### CPR Ring Pack Configuration

New piston ring standard for large bore engines

SL2016-611/JAP  
January 2016

New CPR ring pack configuration standard for large bore engines of the above mentioned type.

**Fig. 1:** Piston crown with three high piston ring grooves and the corresponding CPR ring pack (i.e., 3 high rings).

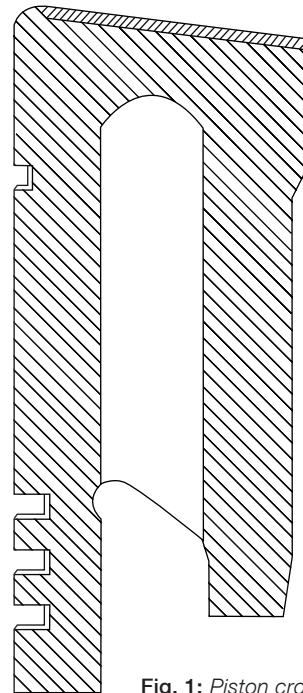
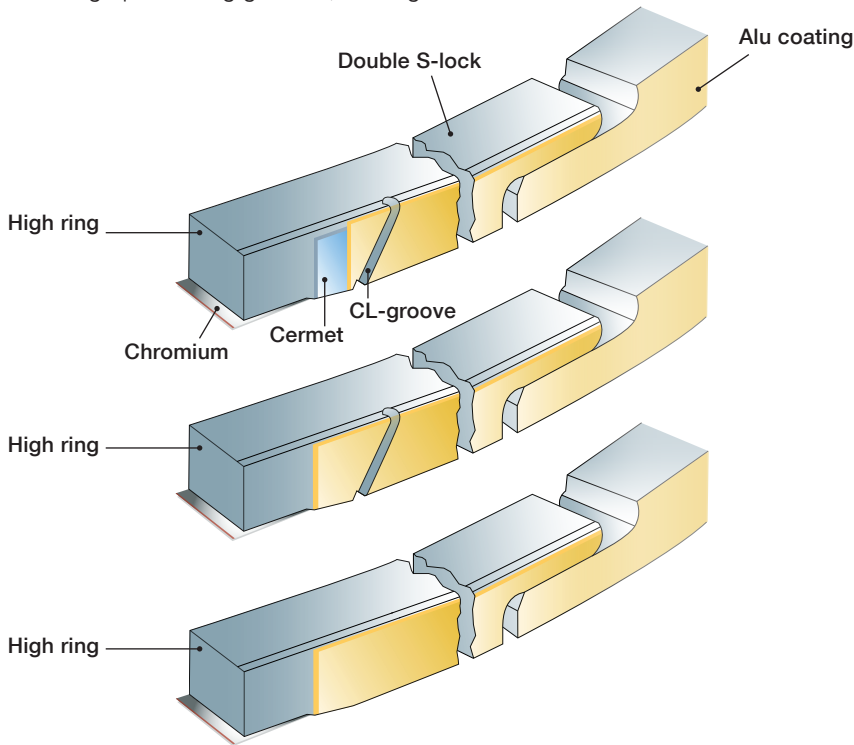
**1.** New engines will be specified with piston crowns with three high piston ring grooves, see Fig. 1.

**Fig. 2:** Piston crown with four piston ring grooves and the corresponding CPR ring pack (i.e., 1 high & 2 low rings).

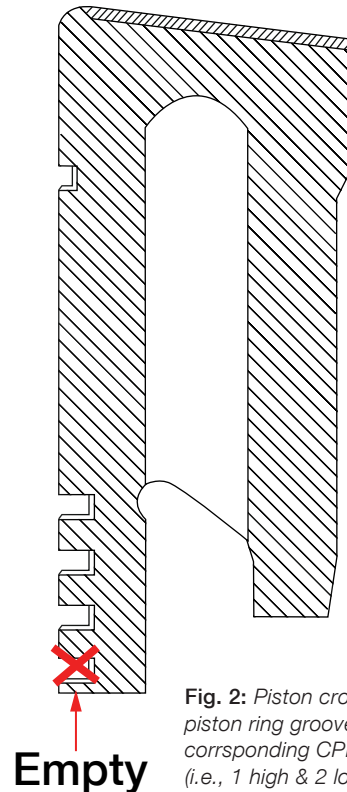
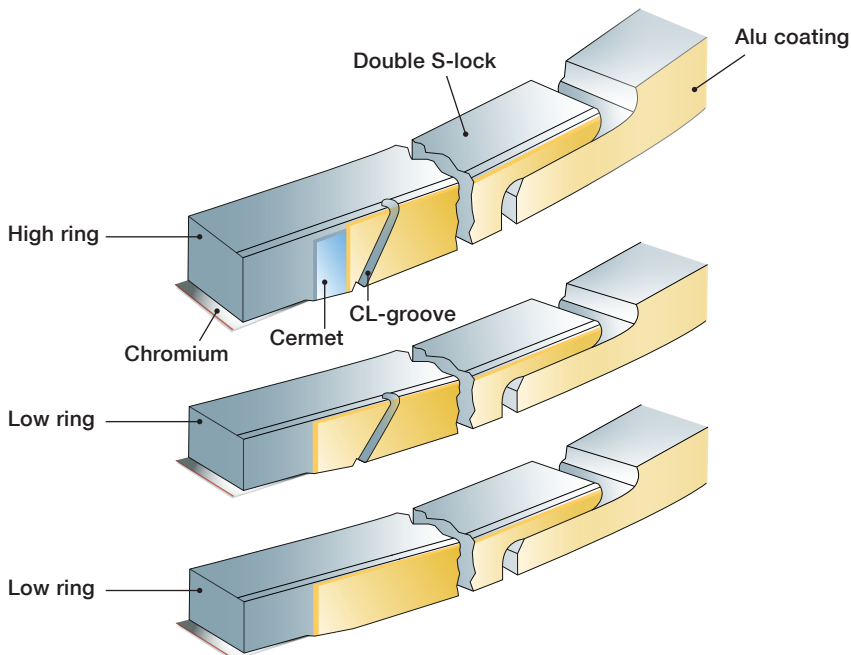
**2.** Engines already in service with four groove piston crowns will continue as four ring groove piston crowns with the CPR piston ring pack shown in figure 2 (i.e., 1 high & 2 low rings) leaving the lowest piston ring groove empty.
